UNITED STATES PATENT AND TRADEMARK OFFICE

APPLICATION NO.	FILING DATE	FIRST NAMED INVENTOR	ATTORNEY DOCKET NO.	CONFIRMATION NO.
10/604,703	08/11/2003	David Elder	WT-001	1702

Office Action Summary	Application No. 10/604,703	Applicant(s) ELDER ET AL.	
	Examiner Pia F. Tibbits	Art Unit 2838

DETAILED ACTION

**Fig. 1**

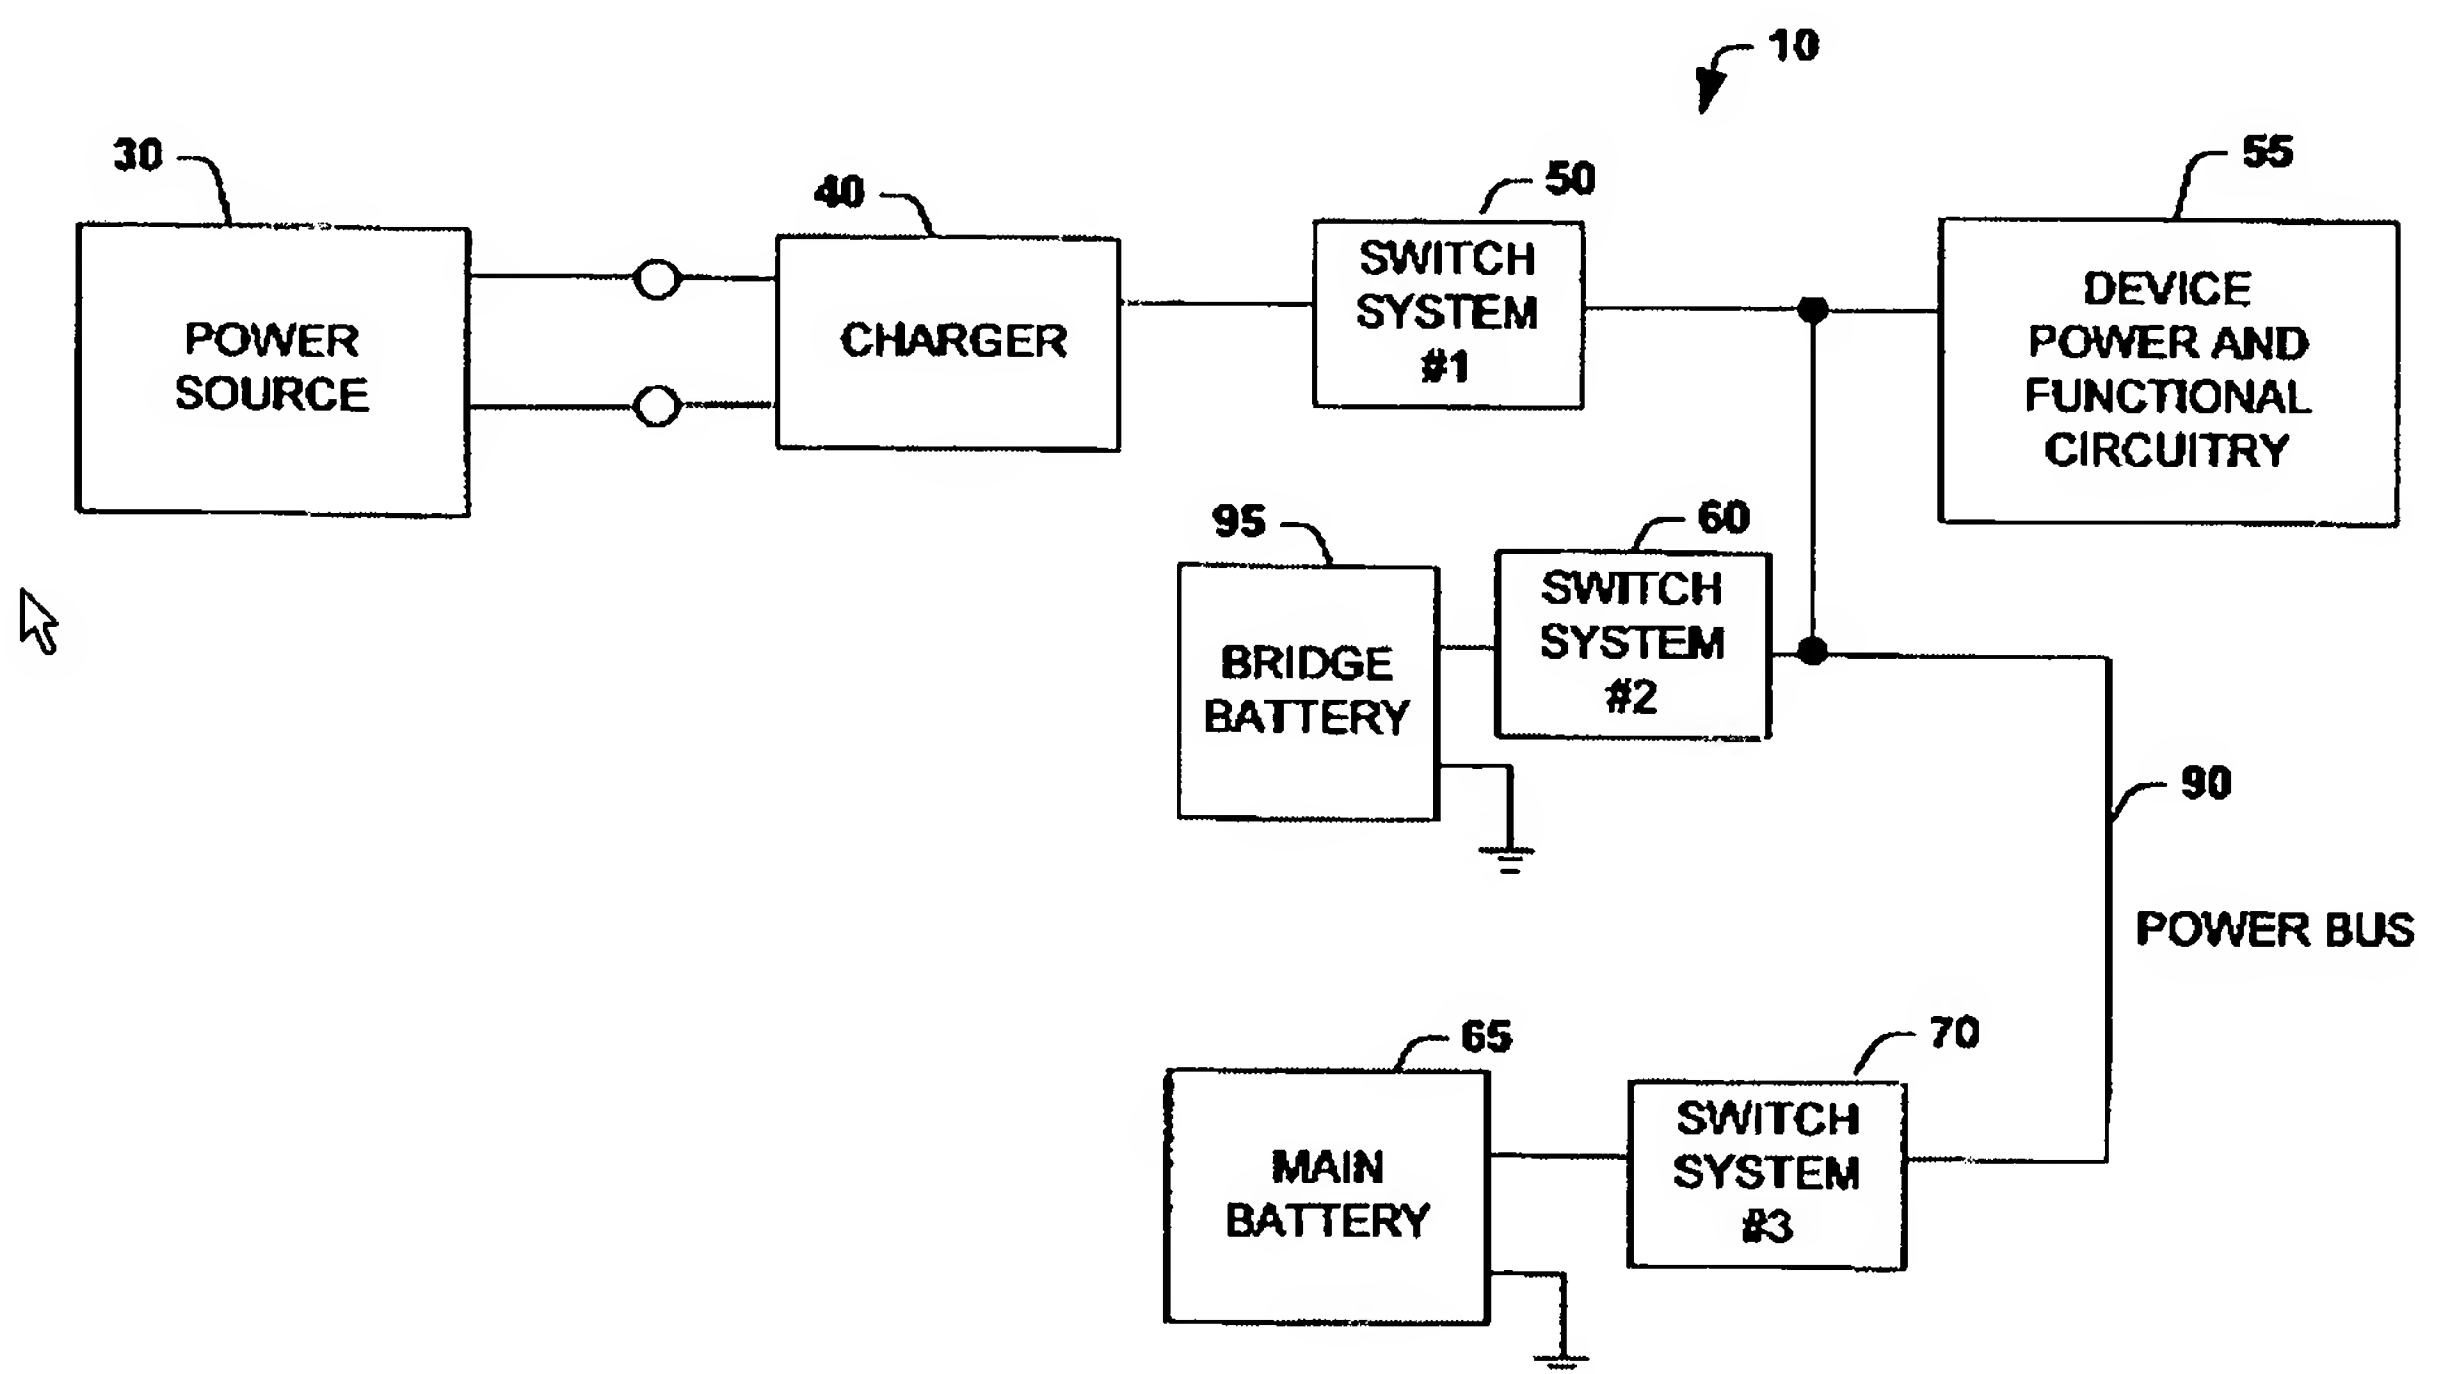
a one-way charging circuit/diode electrically connected between the main positive output and the at least one standby positive output, the one-way discharging circuit configured to facilitate discharging of and prevent current flow from the at least one standby battery at all times during which the main battery is supplying electrical energy to the electrical system.

Leppo does not disclose a switching device operable in two operating positions to at least selectively electrically connect the system positive terminal to one of the main positive output and the at least one standby positive output, the switching device being operable in a first operating position/"push the switch back to the main battery/unit" to electrically connect the main positive output to the system positive terminal and electrically disconnect the system positive terminal from the at least one standby positive output, the switching device being further operable in a second operating position/"push switch to the live reserve unit" independent of the first operating position to electrically connect the at least one

It would have been obvious to a person having ordinary skill in the art at the time the invention was made to make integral the control for the main battery or the standby/bridge battery, since it has been held that forming in one piece an article which has formerly been formed in two pieces and put together involves only routing skill in the art. *In re Larson*, 340 F.2d 965, 968, 144 USPQ 347, 349 (CCPA 1965). See MPEP 2144.04.
